**UNITED STATES OF AMERICA
NUCLEAR REGULATORY COMMISSION
BEFORE THE COMMISSION**

September 6, 2012

PILGRIM WATCH COMMENT REGARDING SECY-12-110, CONSIDERATION OF ECONOMIC CONSEQUENCES WITHIN THE NRC'S REGULATORY FRAMEWORK

At the August 29 Public Meeting (Slide 17), the Staff reviewed three options set forth in SECY-12-110 and will recommend that the Commission approve Option 2, September 13th.

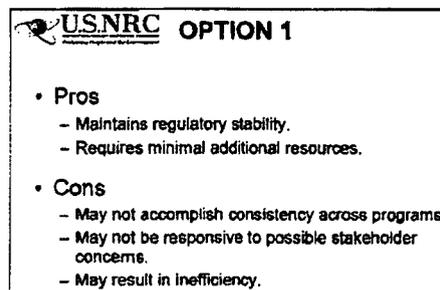
The Staff also suggested that Pilgrim Watch ("PW") provide written comments regarding SECY-12-10 and these options. For the reasons set forth in more detail below, PW recommends that none of the Staff's three options be approved in their present form. Instead, PW recommends that the Commission accept an amended version of Option 3: change the regulatory framework to incorporate the real-world lessons learned from Fukushima.

For each of its options, the Staff presented what it viewed as that Option's Pros and Cons. PW's evaluation of the three Options is significantly different.
